Inspection Report Minerals Regulatory Program

Report Date: September 10, 2004

Mine Name: ECDC Clay Mine Operator or Permittee Name: ECDC Environmental Permittee Mailing Address: 1111 West Hwy. 123, P. O. Box 69, East Carbon, Utah 84520 Inspector(s): Paul Baker Other Participants: None Permit Status: Inactive Current Acreages:	Permit number: M/015/062 Inspection Date: June 30, 2004 Weather: Mostly clear, 80's Inspection Start Time: Abt. 12:15 PM Inspection End Time: Abt. 1:45 PM Site location/Area Inspected (i.e. Pit #): Entire site Surface Ownership: Fee Mineral Ownership: Fee			
Total Permitted (Bonded): 25	Mineral Mined: Clay			
Total Disturbed: Not measured	Type of	f Mine: Surfa	ace	
Elements of Inspection	Evaluated	N/A	Comment	Enforcement

Photo 3. The remains of straw bales along the overburden/spoil pile.

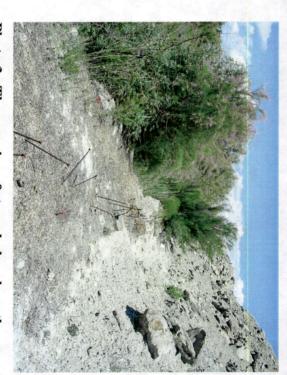
In 2001, I asked the operator to install sediment control along a section of an overburden pile, and a row of straw bales was placed along the base of this pile. These bales have deteriorated and probably control little sediment (Photo 3). Although I considered asking the operator to maintain these straw bales, the overburden pile and adjacent riparian area look almost identical to a nearby undisturbed area (Photo 4). Therefore, I do not feel there is a need to maintain the straw bales, but the Division and the operator should monitor this area for accelerated erosion and sediment additions to the river.

Photo 5. The topsoil stockpile.

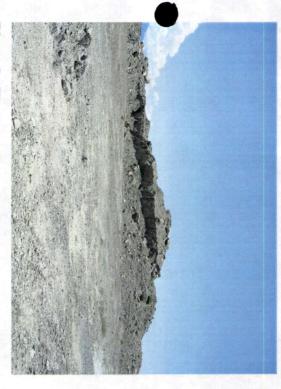
The soil pile is shown in Photo 5. The operator needs to ensure that this material is not used for anything other than reclamation, and I suggest putting a sign on the pile advising people that it is topsoil. I also suggest that the operator try to establish vegetation on this pile. The next time equipment is brought to the mine, the pile could be worked so it is very rough without the near-vertical slopes. It could then be seeded.
